Rezoning Petition No. 201404014

DEPARTMENT OF COMMUNITY DEVELOPMENT RECOMMENDATION

The Applicant has applied to rezone the subject properties from C-1 (Community Business District) to MIX (Mixed Use District) to construct a mixed use development.

ZONING SITE PLAN
MILL CREEK AT SANDY SPRINGS

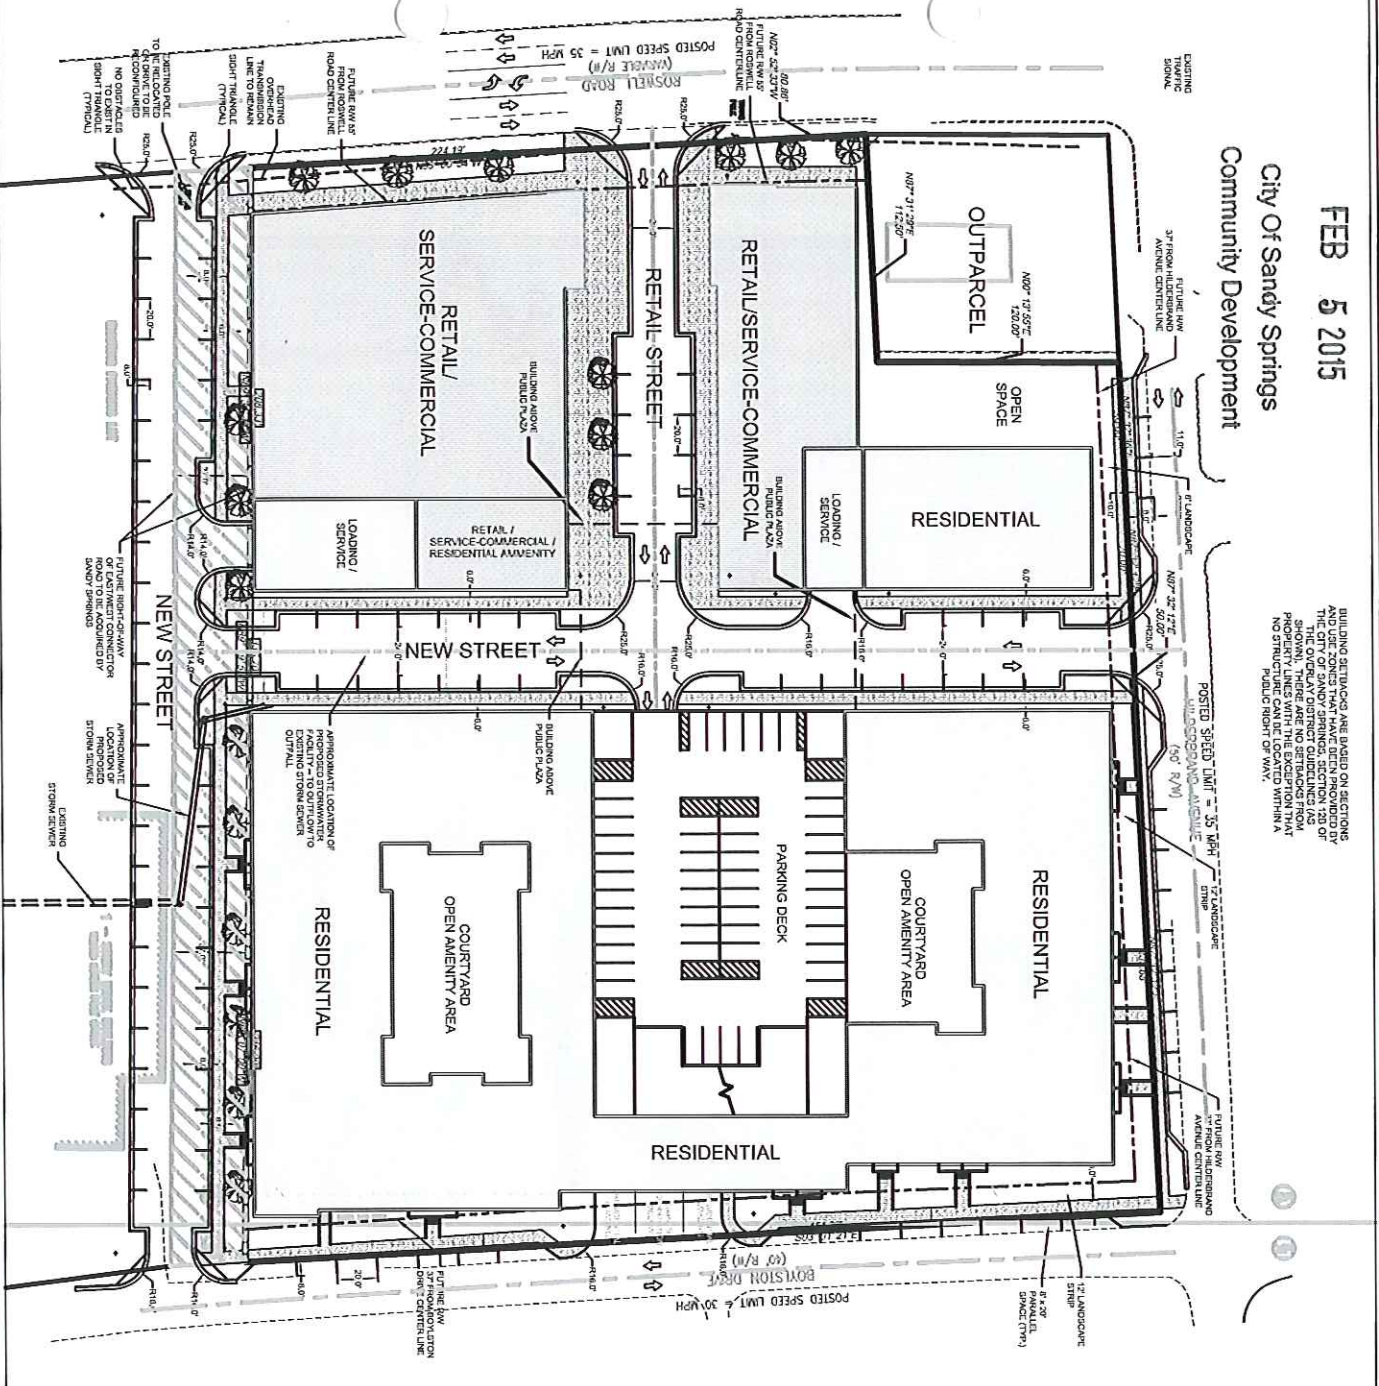
The project as depicted on the revised site plan is inconsistent with the following polices set forth in the Comprehensive Plan:

Strategy 3- Support mixed-use neighborhoods with a network of walkable streets – The revised site plan reduces public spaces and does not develop walkable streets including the new street and on Boylston Drive. Further analysis would be helpful.

Staff is of the opinion that the request to delete the 60% transparent glazing requirements as presented is not in harmony with the intent of the Zoning Ordinance and City Center Master Plan. This variance request would only apply along frontages with first floor residences which include: Hilderbrand Drive, Boyleston and the newly created road on the south side of the property. No elevations have been presented which would provide engagement with the street along the frontages seeking a variance. Therefore, based on these reasons, the staff recommends **DENIAL** of this variance request.

Staff is of the opinion that the request to locate buildings within 3 feet of the right-of-way is not in harmony with the intent of the Zoning Ordinance and City Center Master Plan. This variance would greatly reduce amount of supplemental area required between the building façade and the street curb. These supplemental areas are key in developing public spaces and walkability within the City Center study area. Therefore, based on these reasons, the staff recommends **DENIAL** of this variance request.

Capital Improvement Program (CIP)	None.
Stormwater Services	Site plan should indicate proposed stormwater management and consider offsite stormwater flows through the project.
Field Services	None.

2. To the owner's agreement to abide by the following:
 - a. To the site plan received by the Department of Community Development on February 5, 2015. Said site plan is conceptual only and must meet or exceed the requirements of the Zoning Ordinance, the Development Standards contained therein, and these conditions prior to the approval of any Land Disturbance Permit. In the event the Recommended Conditions of Zoning cause the approved site plan to be substantially different, the applicant shall be required to complete the concept review procedure prior to application for a Land Disturbance Permit. Unless otherwise noted herein, compliance with all conditions shall be in place prior to the issuance of the first Certificate of Occupancy.

- i. Roswell Road, Hilderbrand Road, Boylston Drive and newly created streets and alleys shall employ a street design in accordance with the City Center Master Plan.
- j. Relocate the north "Loading/Service" element behind residential in "Open Space" element with access from Hilderbrand Road; relocate "Open Space" element to the north-south "New Street".
- k. Eliminate "Retail/Service/Commercial/Residential Amenity" element and replace with open space as shown in earlier site plans.
- l. Create a minimum of 20% open space on the property.
